## ETIHAD STADIUM NORTH STAND EXPANSION

### Addendum to Stage 3 Part 2 Construction Hoarding – crowd movement assessment

Following receipt of 12588700 Addendum to MCFC Construction Hoarding Impact Assessment Stage 3 Part 2 Crowd Modelling\_DRAFT.pdf and comments-12588700 Addendum to MCFC Construction Hoarding Impact Assessment Stage 3 Part 2 Crowd Modelling\_DRAFT.pdf please find below my comments.

**Crowd Risk Analysis Ltd (CRA) notes on 12588700 Addendum to MCFC Construction Hoarding Impact Assessment Stage 3 Part 2 Crowd Modelling\_DRAFT.pdf.**

Minimum pedestrian circulation widths (metres) considered in the original construction hoarding modelling (12588700-230412 MCFC Construction Hoarding Impact Assessment Stage 3 Part 2 Crowd Modelling\_DRAFT.pdf)

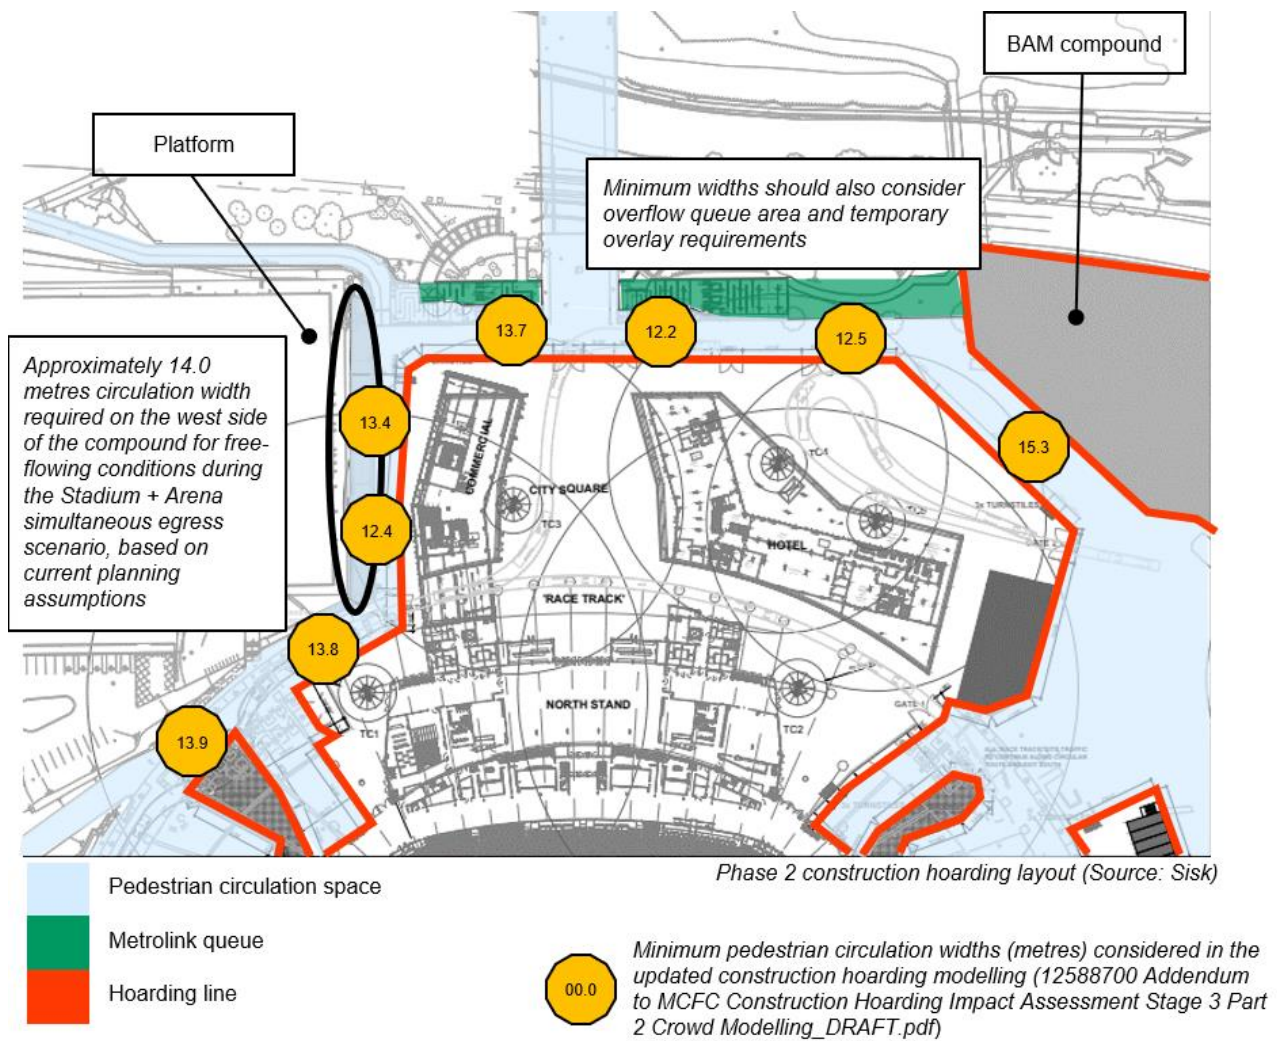
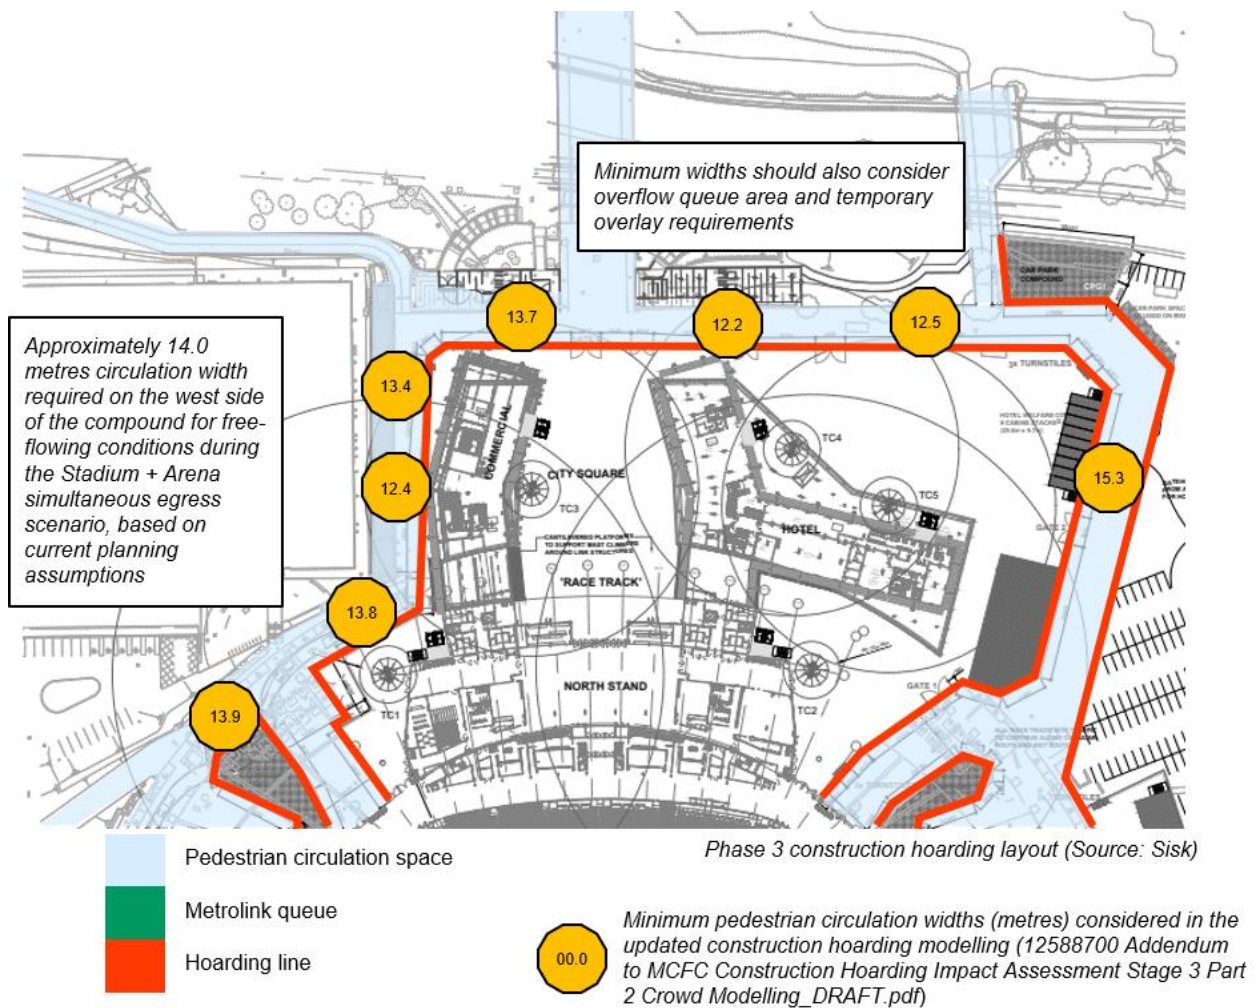
It should be noted that:

- The minimum circulation widths presented may represent a width at a specific location, rather than across a whole route (spectator direction of travel and/or merging may need to be considered at various locations along a given route).

- In general terms, the contractor should attempt to provide circulation routes more than the minimum circulation widths presented (also bearing in mind that significant differences in circulation width in localised areas, or funnelling, may not be beneficial).

Understood and during operations monitoring the crowd with a provision for a short hold and release (stewards asking the crowd to hold for a minute, release for a minute, would facilitate any minor design issues.

Understood and (as above) the provision of a monitoring (CCTV) with radio to instruct hold and release would alleviate any normal egress congestion. In an emergency, the situation may become more dynamic and “hold and release” is not recommended. Normal operations only.
